Re: Formal Objection to SSD-82900461 – Concept Proposal for a Residential Flat Building with In-fill Affordable Housing at 11-19 Middle Harbour Road, Lindfield

I write to formally Object to **SSD-82900461** Concept Proposal for proposed residential flat building with in-fill at **11-19 Middle Harbour Road, Lindfield**, on multiple grounds related to non-compliance with statutory thresholds, planning controls, heritage conservation, environmental impacts, and community consultation deficiencies.

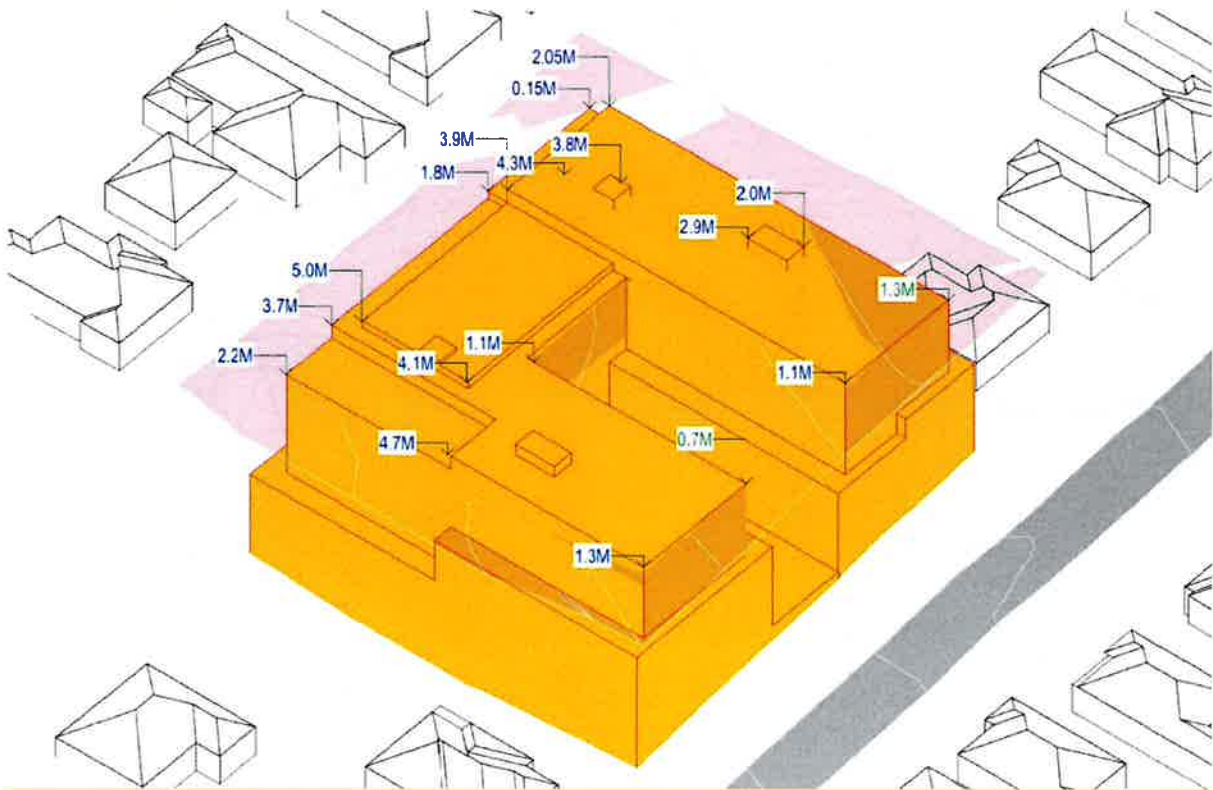
The claimed 450-metre proximity to Lindfield Railway Station to access Transit Oriented Development (TOD) incentives is incorrect.

Independent measurements show approximately 500 metres, exceeding TOD eligibility limits. This misrepresentation undermines the application's credibility and must be corrected.

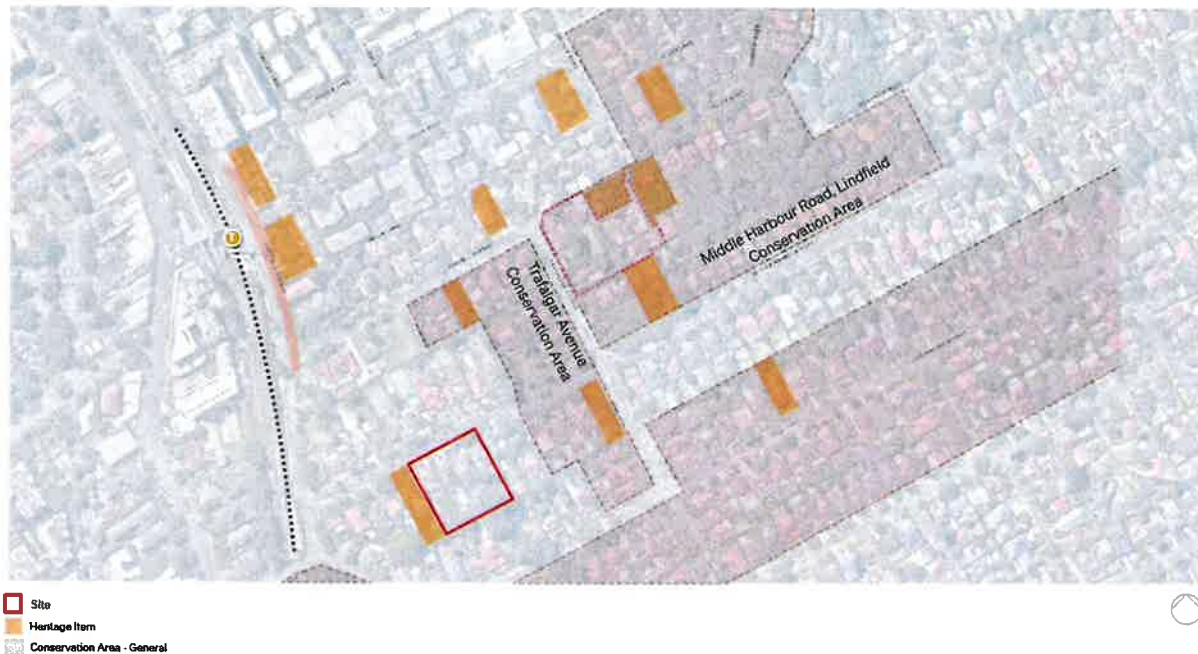
The proposed maximum height of 33.6 metres breaches the 28.6-metre limit by 5 metres (17.48%). This excessive height harms local character, amenity, and visual harmony, causing overshadowing and visual intrusion.

The applicant's use of Housing SEPP "bonus" provisions to exceed base height is unjustified and conflicts with local planning controls and the Council's Preferred Housing Scenario.

Figure 3: Areas of Biodiversity Value (purple) mapped on and near the development site (red). BVMAT last accessed 22nd May 2025.

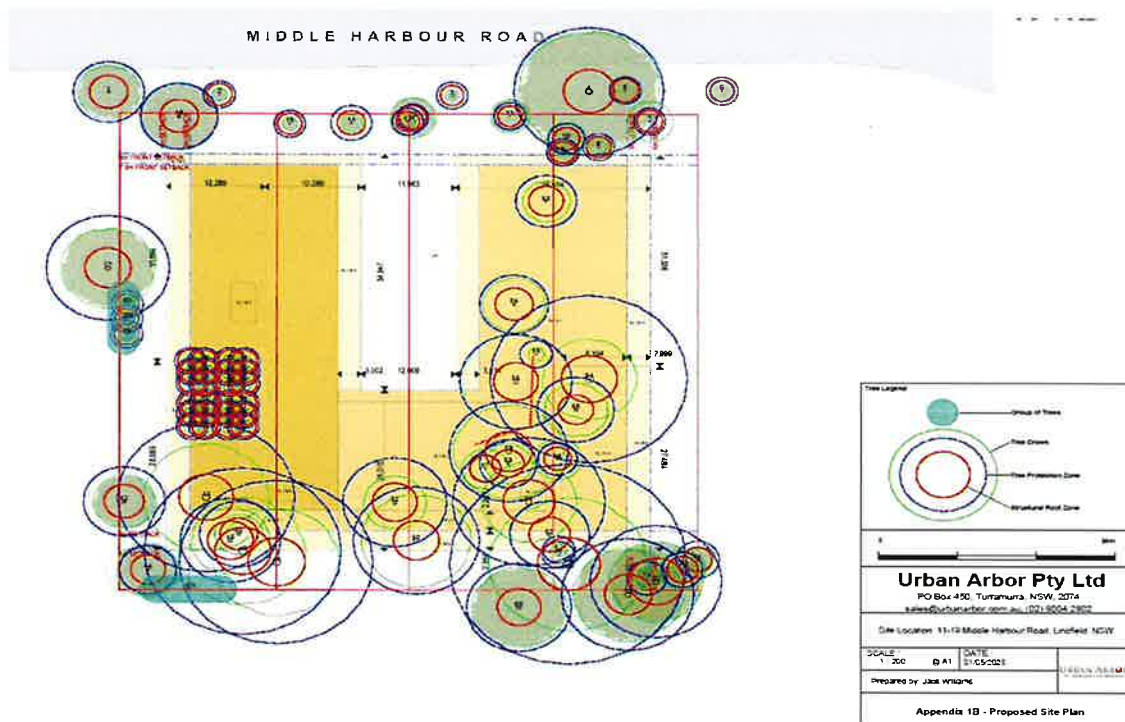
Removal of the majority of mature trees, including ecologically significant Turpentine, results in irreversible loss of urban canopy, biodiversity, and habitat connectivity, contrary to multiple clauses of KLEP 2015 and the Ku-ring-gai DCP.

The Biodiversity Assessment is flawed and over-relies on inadequate compensatory planting.

The development breaches biodiversity and riparian land protections under KLEP 2015 and Biodiversity Conservation Act 2016. Replacement plantings cannot mitigate loss of mature habitat and canopy values
